Wellingdon Inno-Bayshore
425591

BAYVIEW WELLINGTON		
PROJECT NAME: ALCONA	PROJECT NO: 13049	
LOCATION: INNISFIL, ON	DATE: Mar 23, 2023	
SP-2017-051	BLOCK 4 FLOOR PLANS	
DATE: JULY 2017	SCALE: 1/8" = 1'-0"	DRAWING NO: 1
DRWN BY: [Signature]	CHECKED BY: [Signature]	
13049-BLOCKS BL-EXPLODED

BLOCK 4

GROUND FLOOR PLAN 'A'

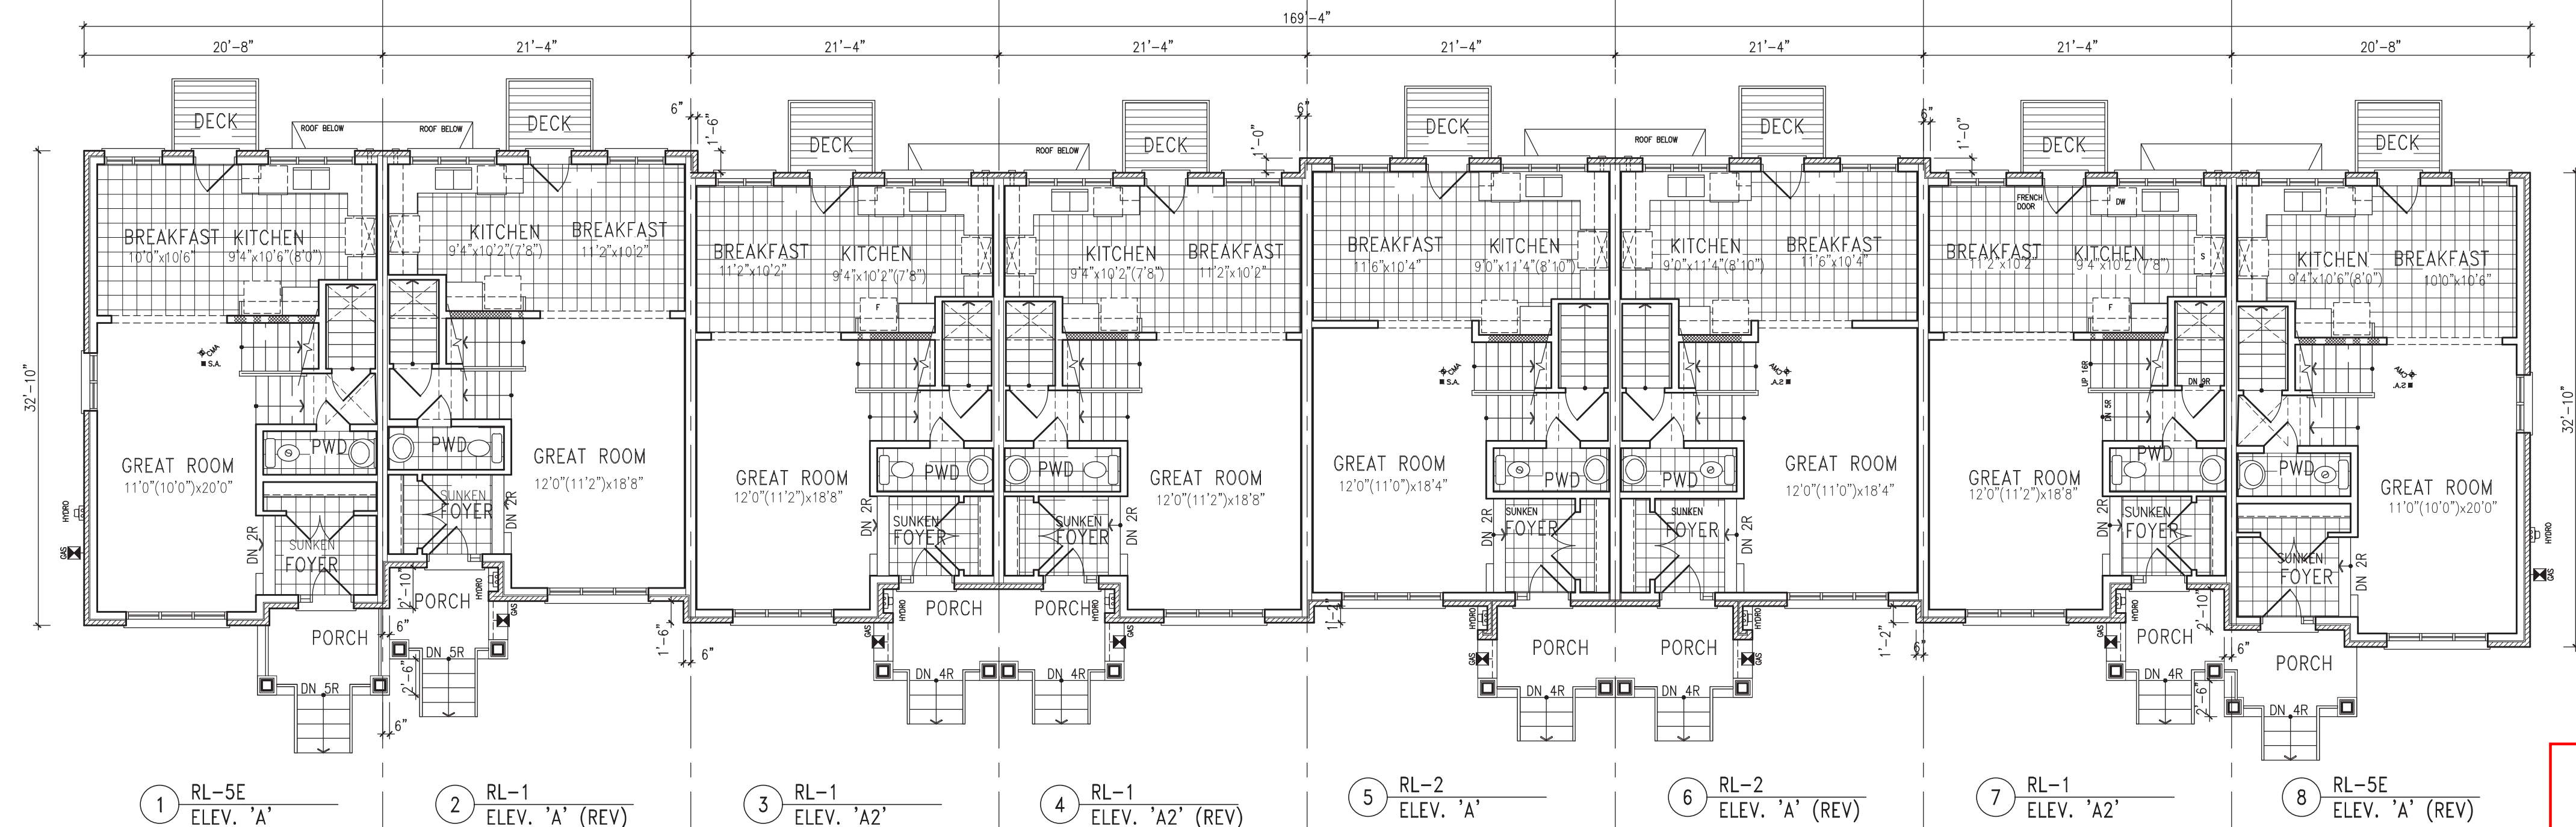
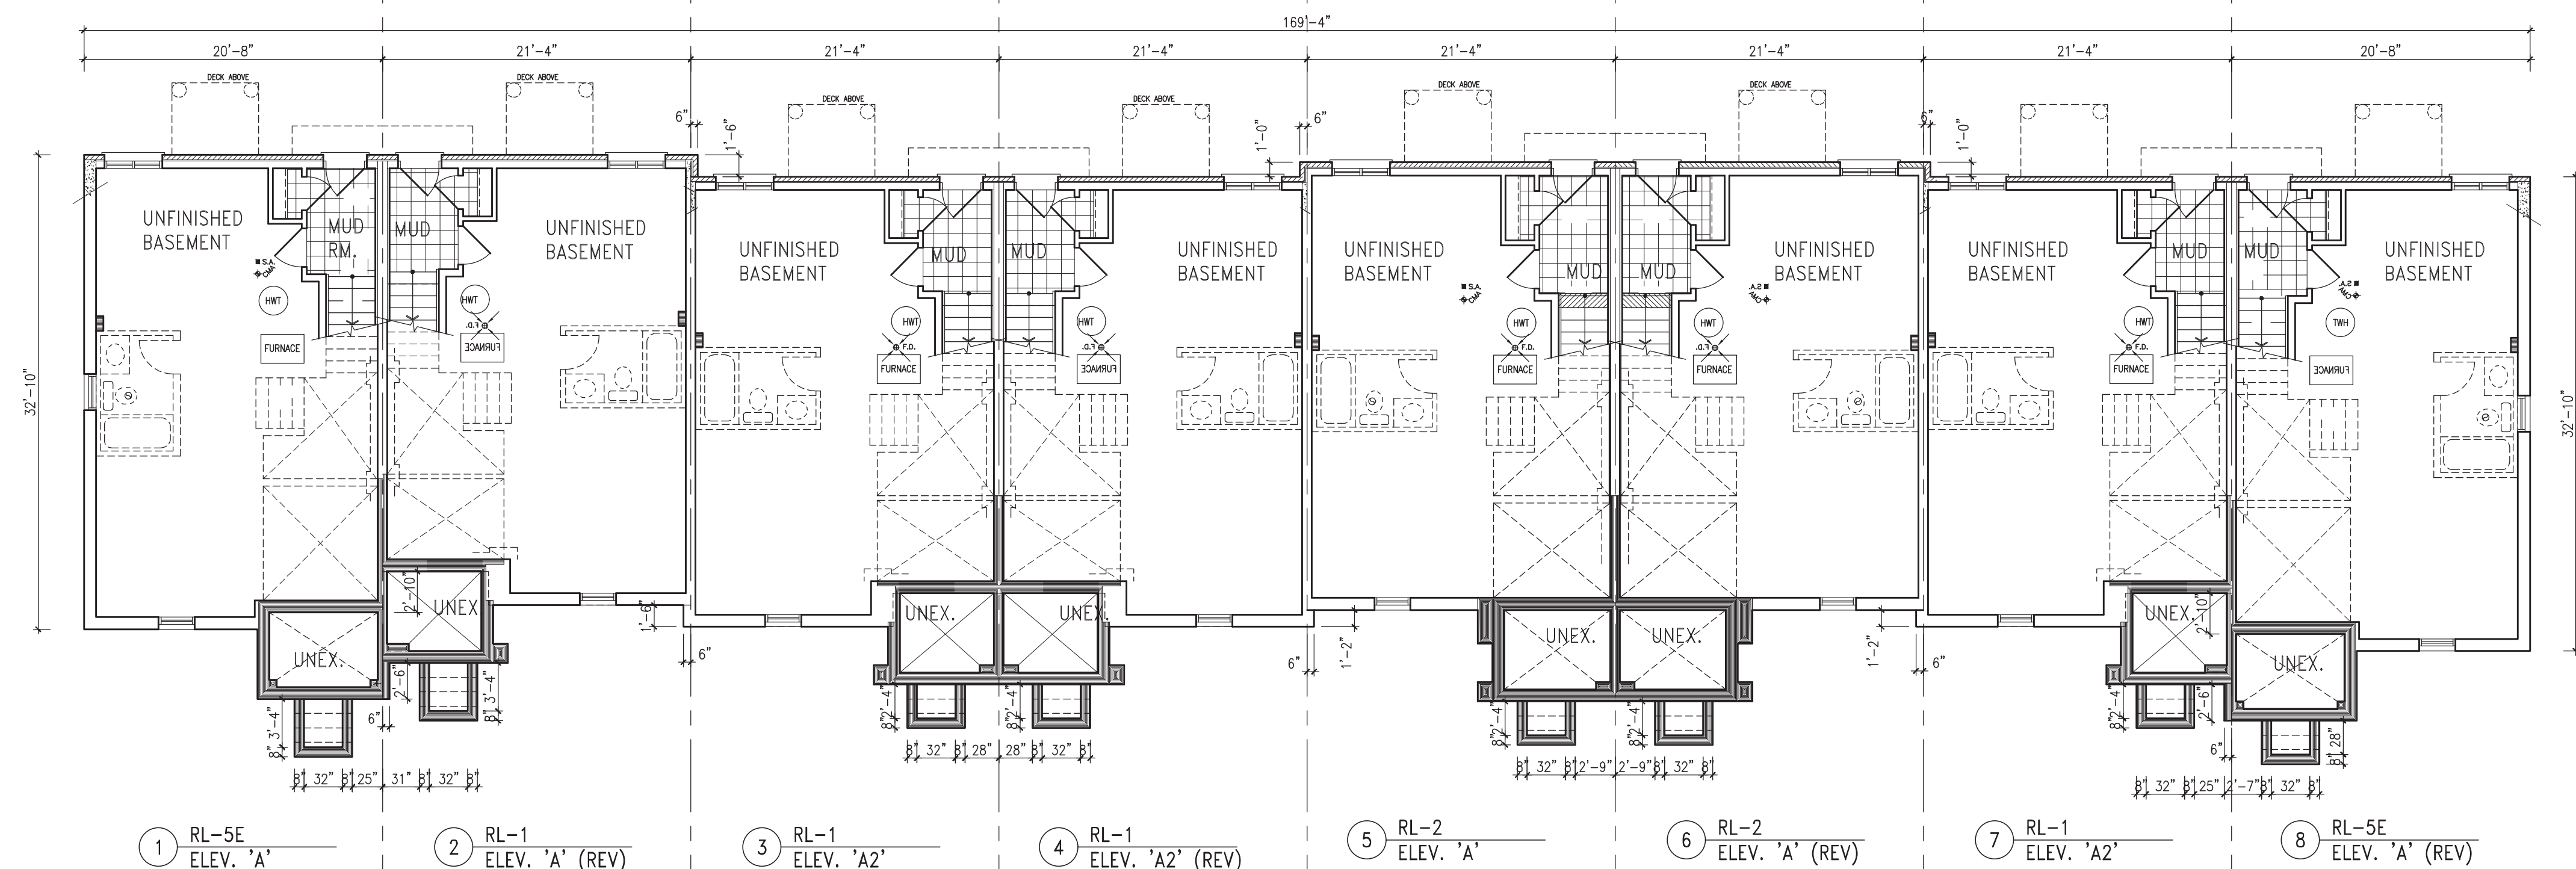
Town of Innisfil Building Dept Notes:

All smoke alarms and CO detectors shall comply with O.B.C 9.10.19 and 9.33.4

Main bathroom shall be designed as per 9.5.2

All construction subject to review by Town Building Inspectors

See comments on permit

Finished basement require separate permits.
